HIGHLAND CITY DEVELOPMENT ADMINISTRATION BOARD AGENDA

DEVELOPMENT ADMINISTRATION BOARD AGENDA REPORT ITEM #1

DATE: October 10, 2024
TO: Development Administration Board
FROM: Rob Patterson, City Attorney / Planning & Zoning Administrator
SUBJECT: **Final Plat Approval:** Foxwood Estates
TYPE: **LAND USE (ADMINISTRATIVE)**

ATTACHMENT 6

Scale: 1"=20'
Date: 09/09/24
Sheet: PP01

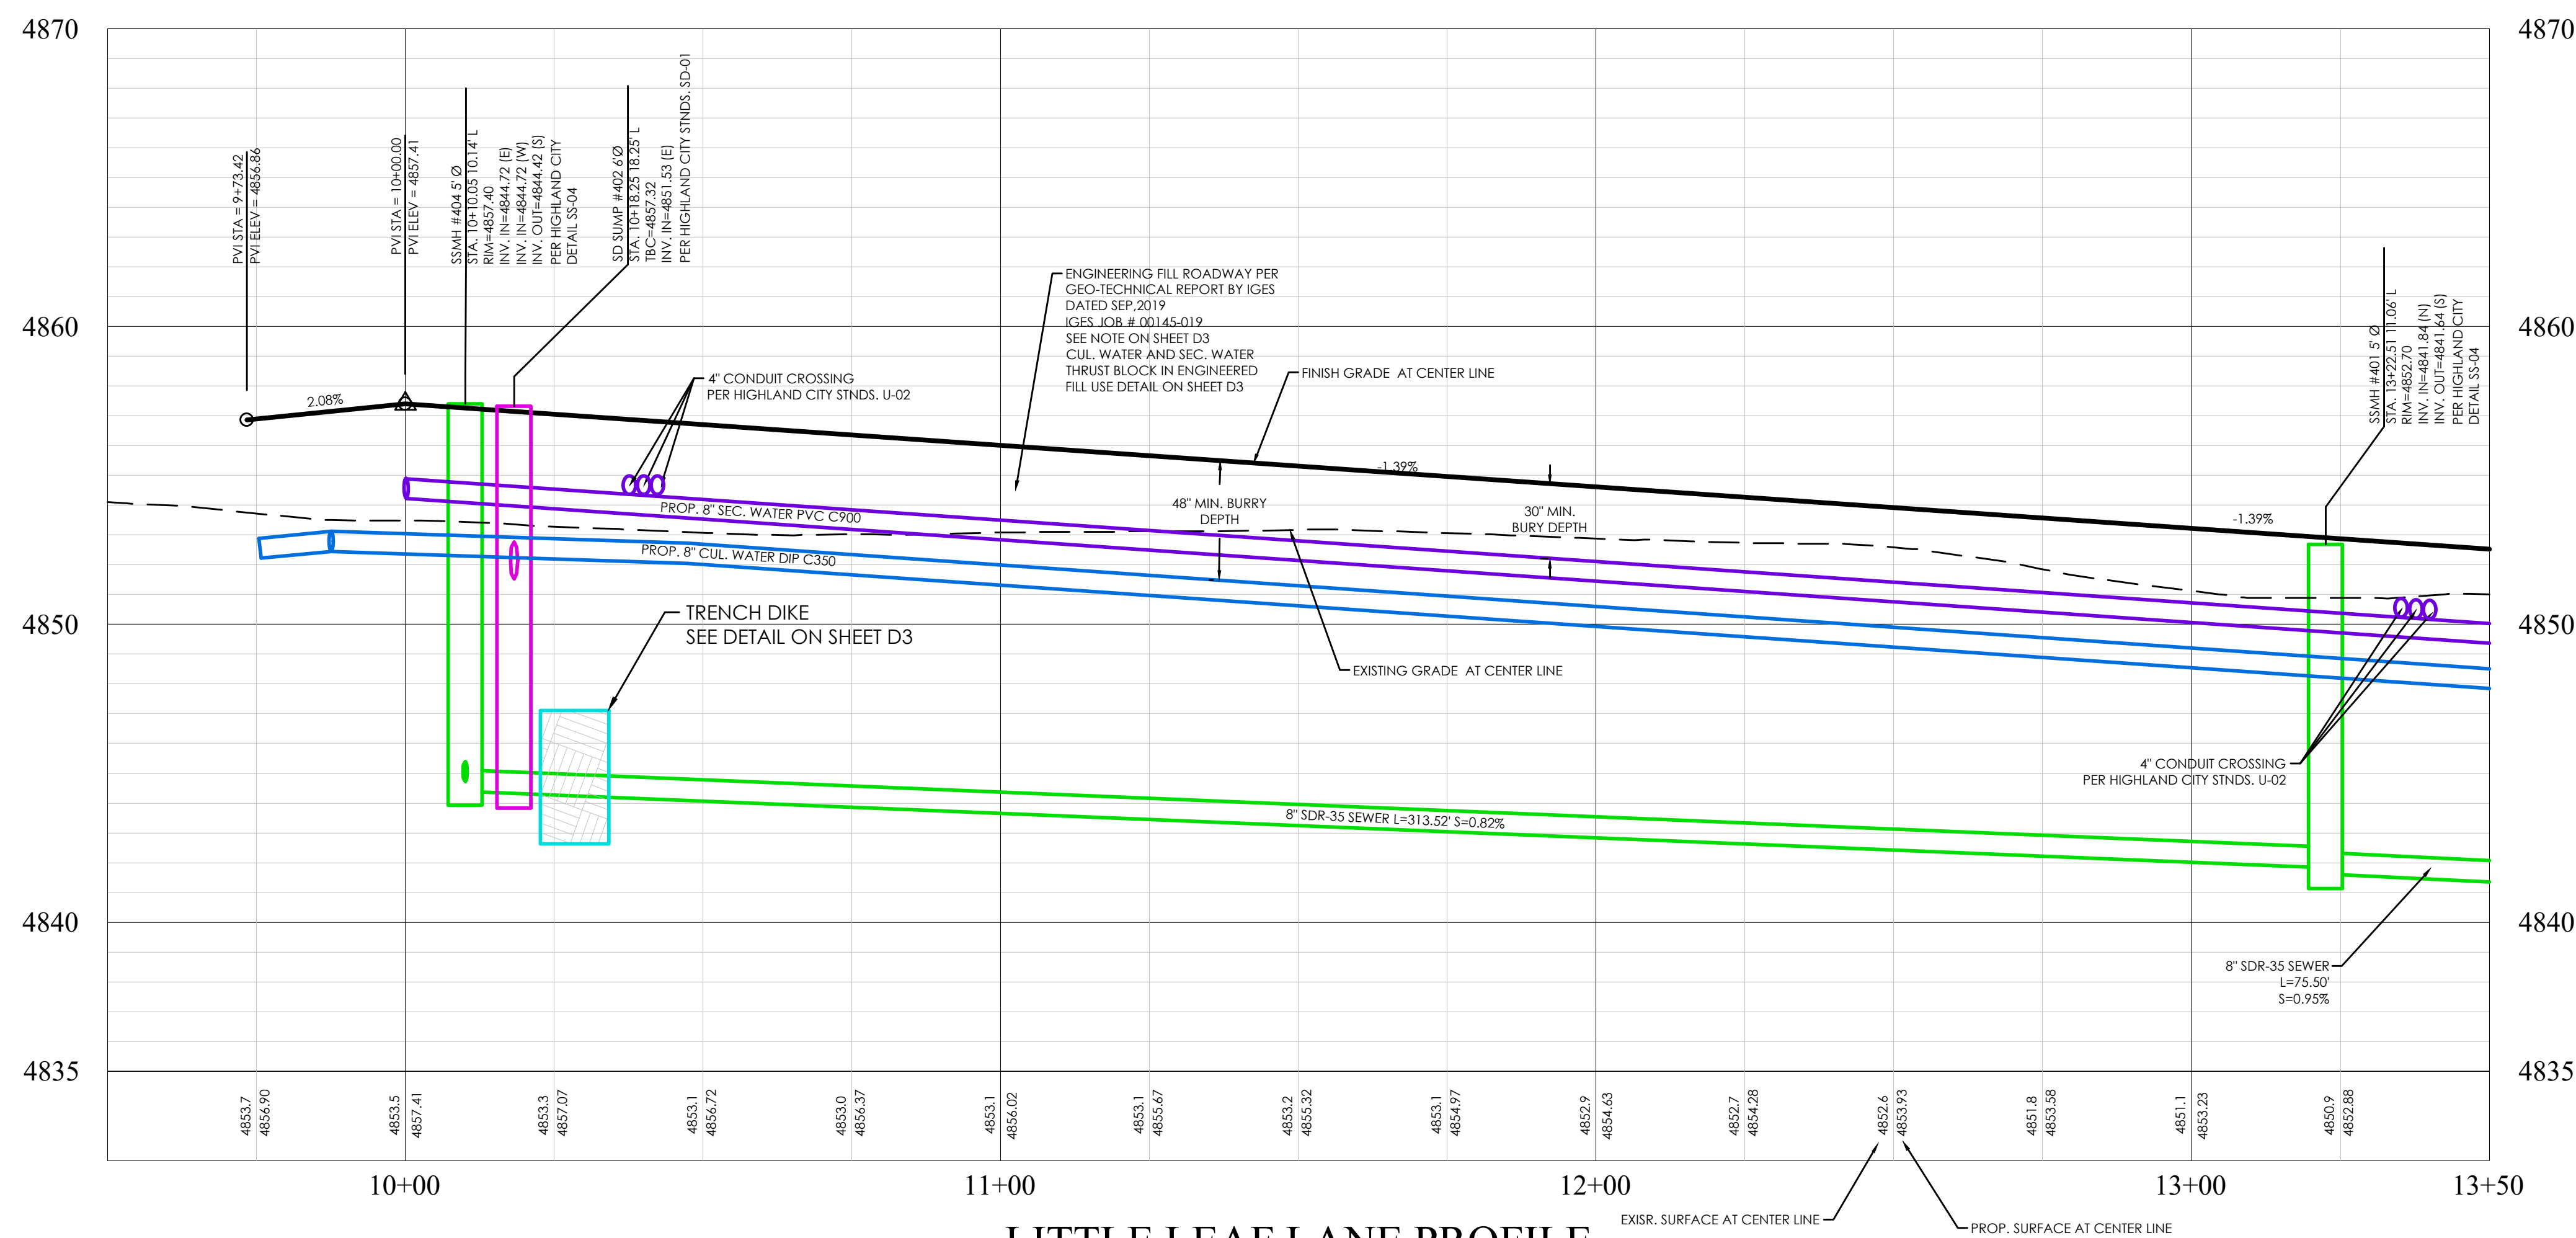
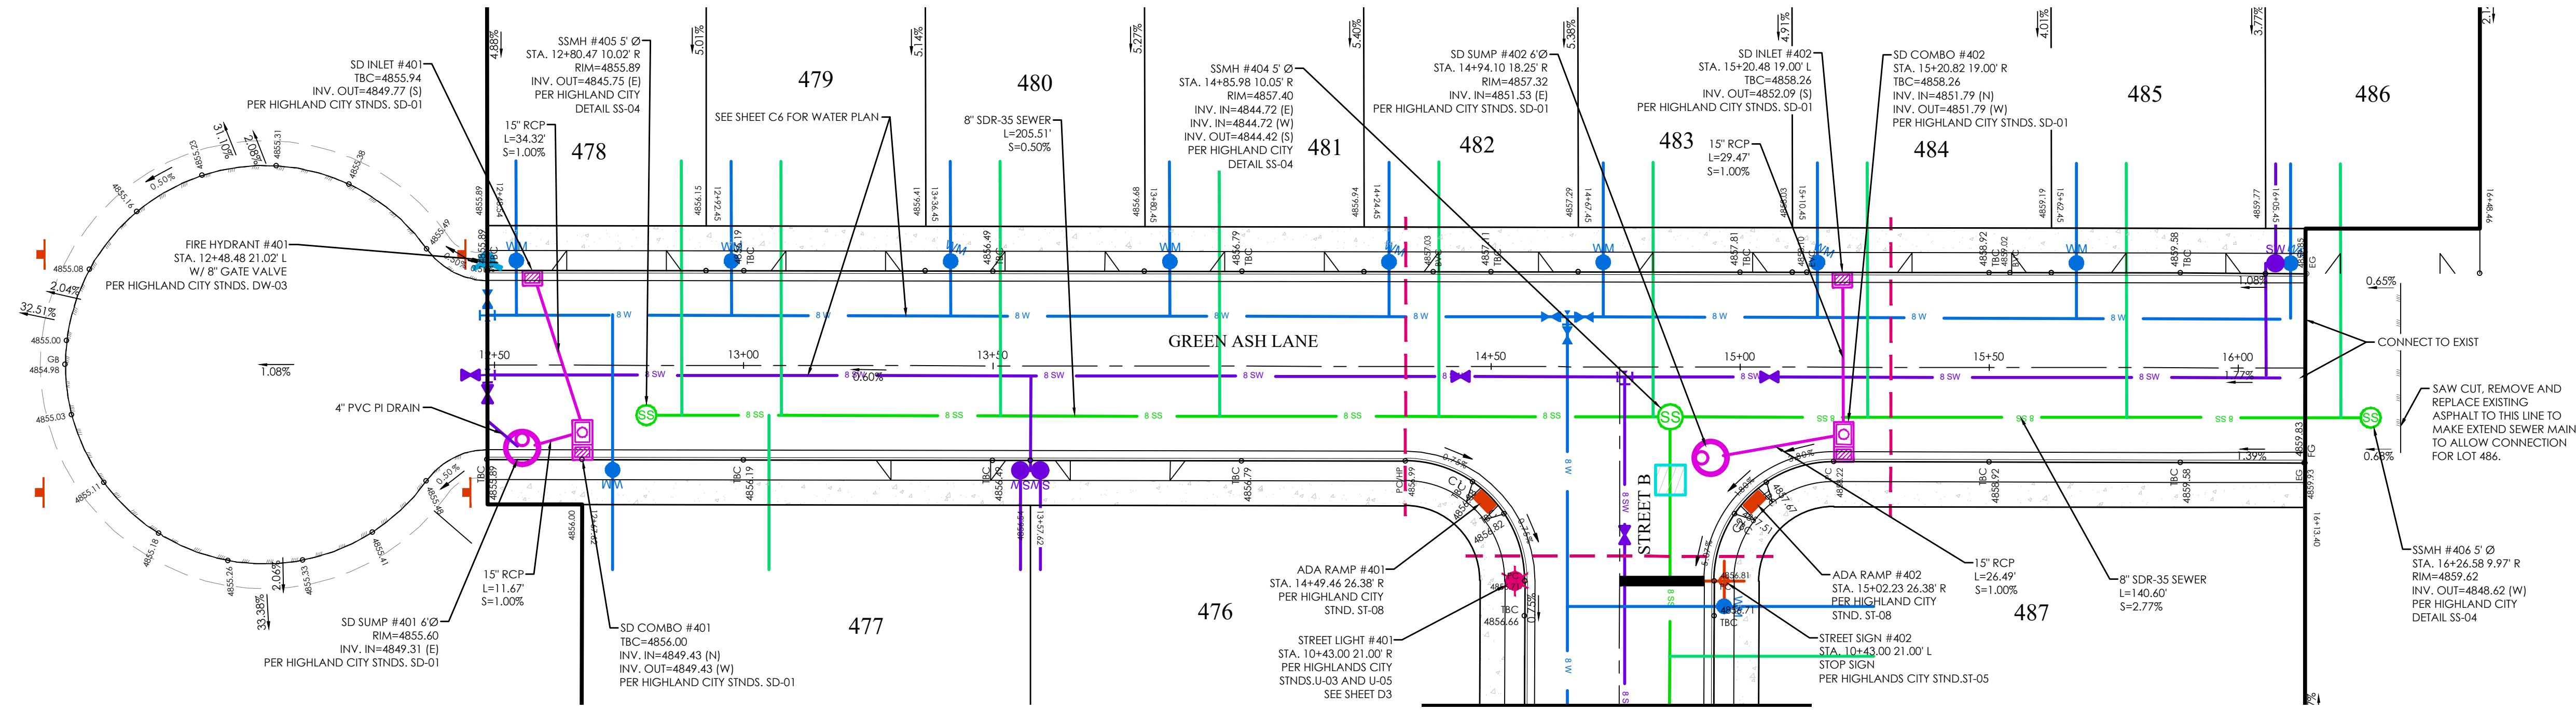
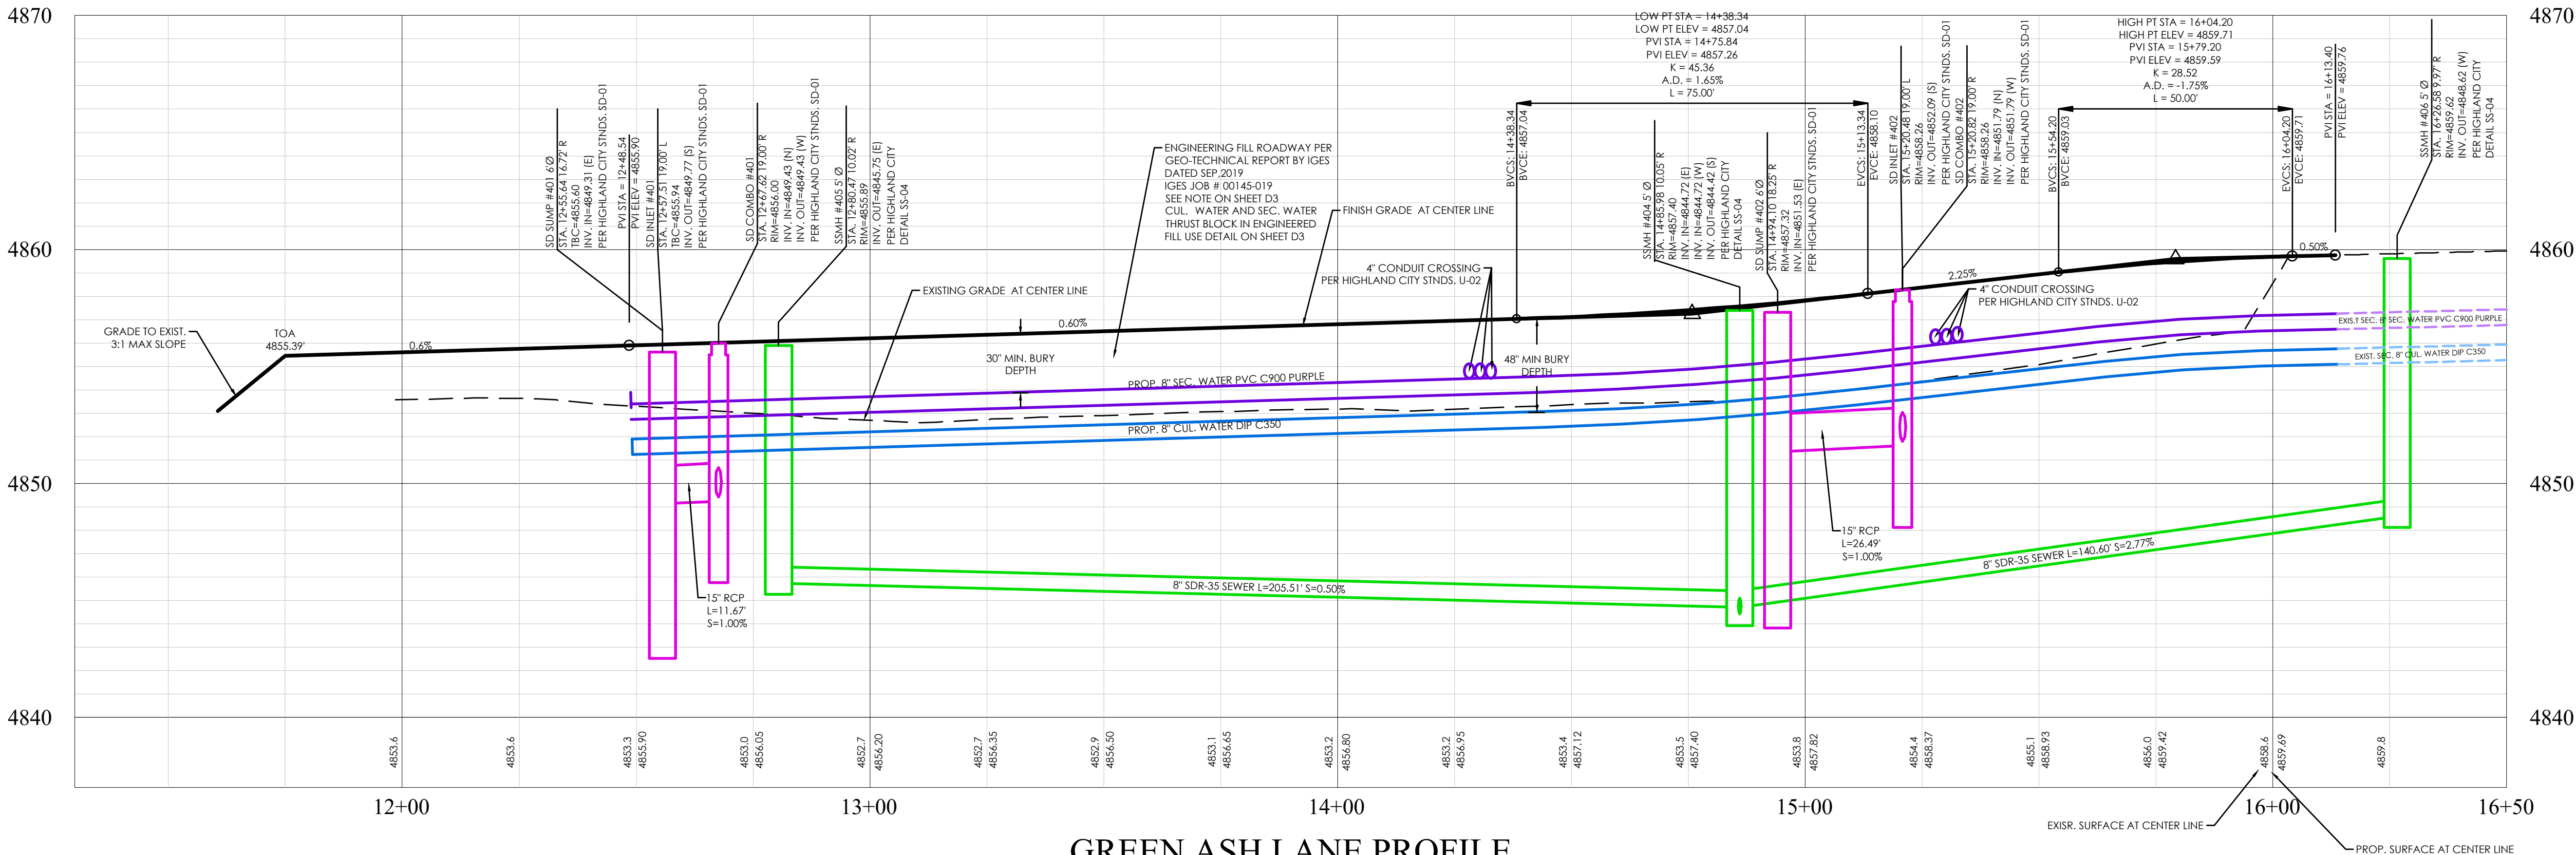
4. Green Ash Lane/Street B, Sheets PP01, PP02, PP03: Remove "Street B" from match lines and from plan views.
5. Crimson Oak Lane, Street Monument, Sheet PP04: Please provide reasoning for the location of the street monument. It does not mark the intersection of the two streets.
